WARRAGAMBA DAM SUBMISSION
PAUL MATTHEWS OCTOBER 2021

Elevation section taken from page 5-8 of “Project Description” document

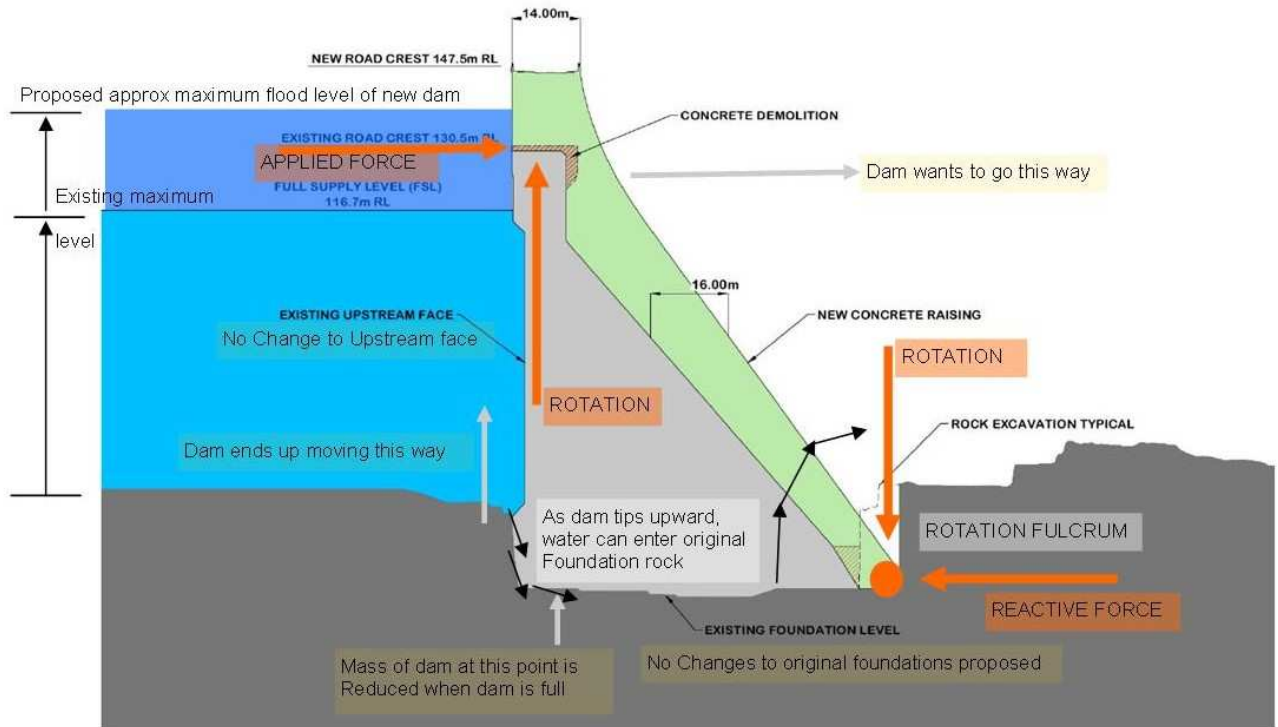
5.) There is NO explanation as to the geological risk of the dam becoming undermined as a result of “gravity dam rotation effect”:

“Gravity Dam Rotation” (refer attached figure) takes place as a result of a dam being made too steep in reference to its base. The downstream base of the dam acts as a rotation point, around which the dam is somewhat free to rotate upwards when the average position of additional force is applied to the top of the dam by increasing the storage capacity.

The Sydney sandstone upon which Warragamba Dam sits, is porous to water and acts somewhat as a sponge to water under high pressure. The downward pressure imposed on the sandstone by the heavy gravity dam, works to create pressure within the rock which is greater than the pressure of the water, ensuring water cannot enter the sandstone and sustaining the dam foundations, preventing ingress of moisture.

However if Warragamba dam is raised in capacity without the addition of substantial upstream deep foundations and mass, **the dam will tend to be “pushed back” when full**. This creates a “rotation effect” on the dam whereby more pressure is placed downward at the downstream base causing a reduction of pressure at the upstream base, in effect **“tipping the dam over”**.

While admittedly it is unlikely the dam would ever be “pushed over”, the action of repeated application and removal of pressure (as the dam is suddenly filled by a flood and then allowed to quickly empty back to supply level) will tend to reduce pressure at the upstream base and allow water to penetrate the existing dam foundations and surrounding rock at each end.

Without adequate engineering treatment such as a drastic increase of the dam mass at the upstream base and increased foundation treatments, the flow of water under the dam through the rock will create cracks and eventually water filled caves through the soft sandstone. Sediment is then washed away into the water table surrounding the dam, eventually finding its way to lower pressure outlets further downstream.

Left to itself, this action will eventually undermine the dam. It will cause dam failure as water attempts to find its way downstream under and around the dam, through the soft sandstone rock fissures that exist. The failure would likely not happen straight away, rather it would happen many decades after the project is

complete and after many flood events have systematically placed and then removed rotational pressure on the dam. Each each flood event will cause a small, invisible amount of movement upwards and subsequent damage in the rock foundations under and surrounding the dam.

Once the damage is discovered it will be too late to do anything about it without draining the reservoir completely. If the damage remains hidden and undetected, total dam failure will become possible. This would likely happen at the worst possible time i.e. during a record flood event when the water table below the dam is already high and the downstream communities and catchments are already flooded and saturated.

The only way the Warragamba dam can be sufficiently extended and reinforced at its upstream base will be to *completely drain the reservoir and provide a bypass tunnel around the dam* for the Warragamba River – as was originally carried out for the initial construction of the dam in the 1950s. The cost of this activity, both in dollar terms and in terms of the loss of Sydney’s water supply for several years, would be immense.
